21-7583

RE: Processing Field Reports for Permit Numbers 21-7442 and 21-7583

Permit #s 21-7442 & 21-7583

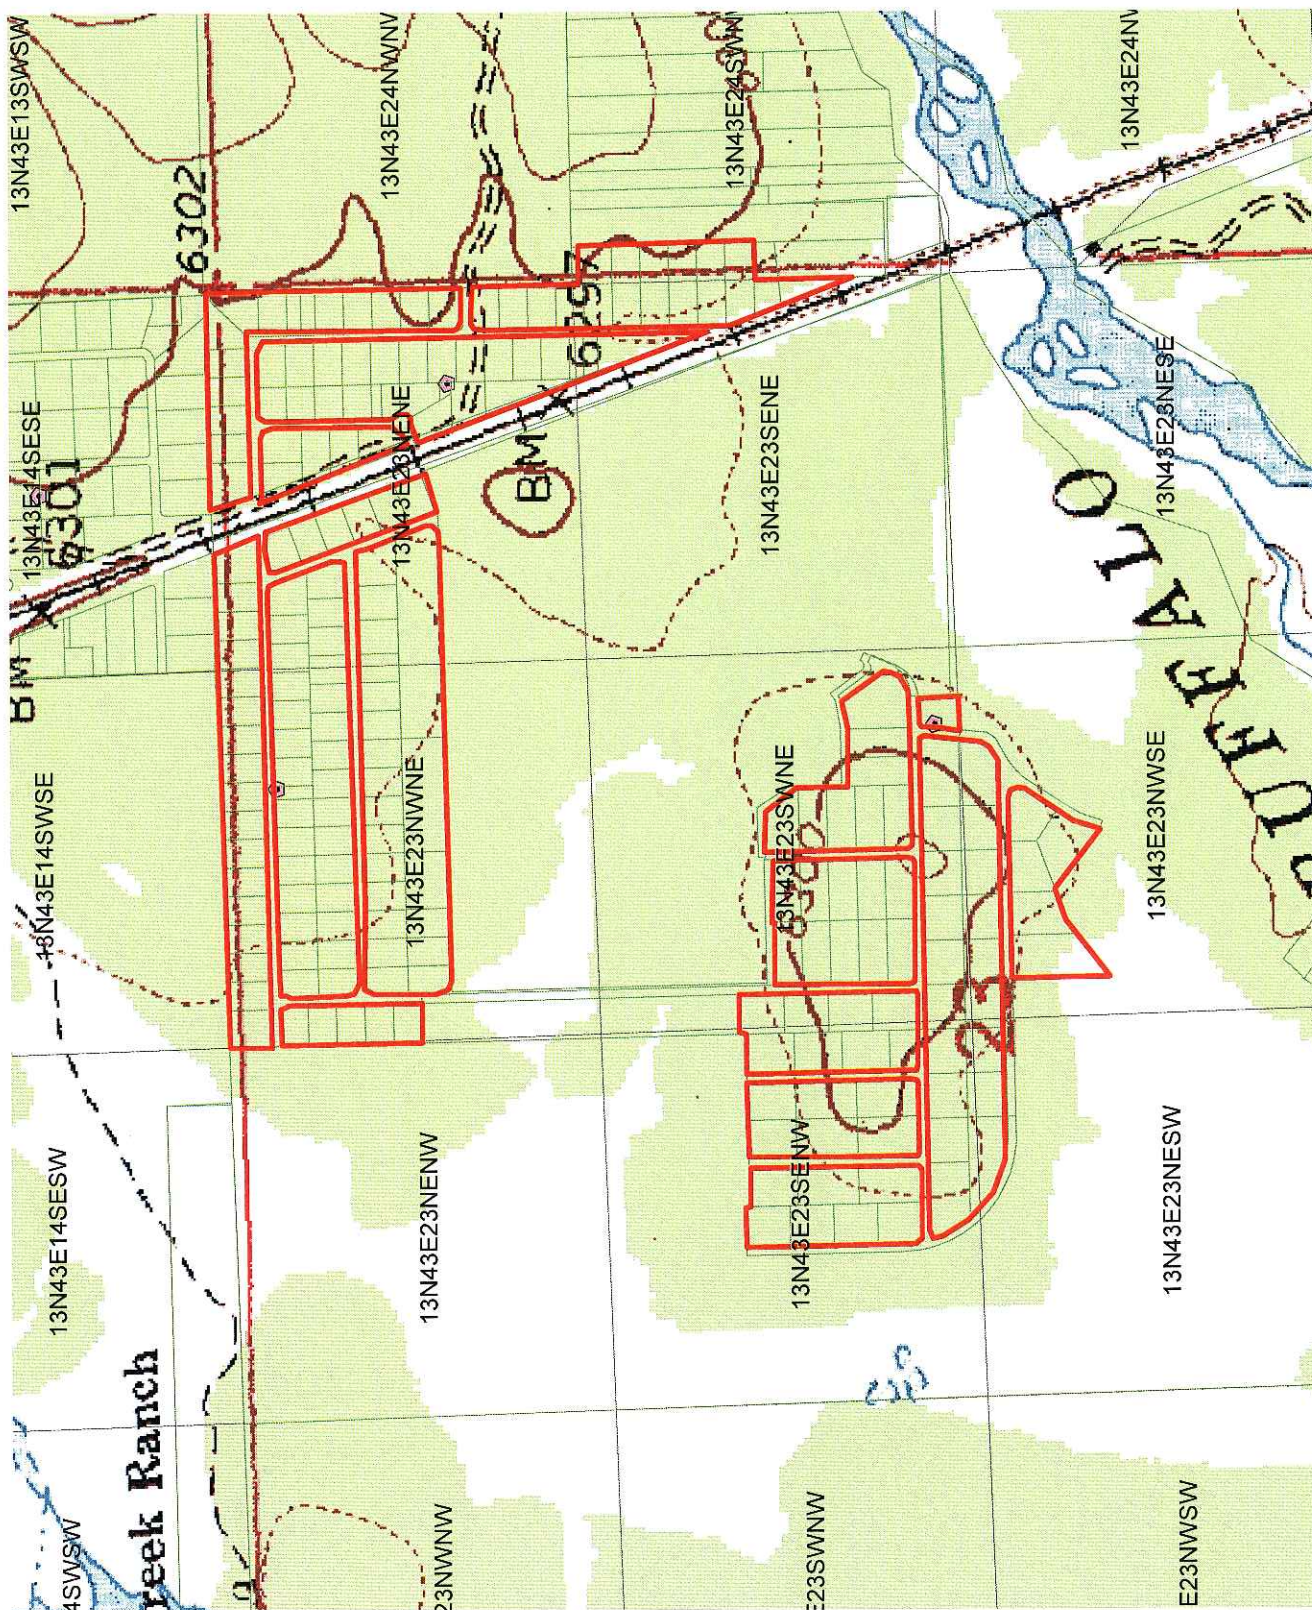
Comment: This system contains three wells. Currently wells #1 and #2 are tied together and deliver water to Subdivisions #1 and #2. The water mains in Subdivisions #1 and #2 are 2 inch and are buried along the edges of the roads. All lots are stubbed in. Proof of Beneficial Use states that this Permit is for use by 50 homes. Subdivision 3 is not connected to the other two subdivisions. It receives its water from Well #3. The mainlines are 4 inch and the trunklines are 3 inch. They also run along the edges of the roads.
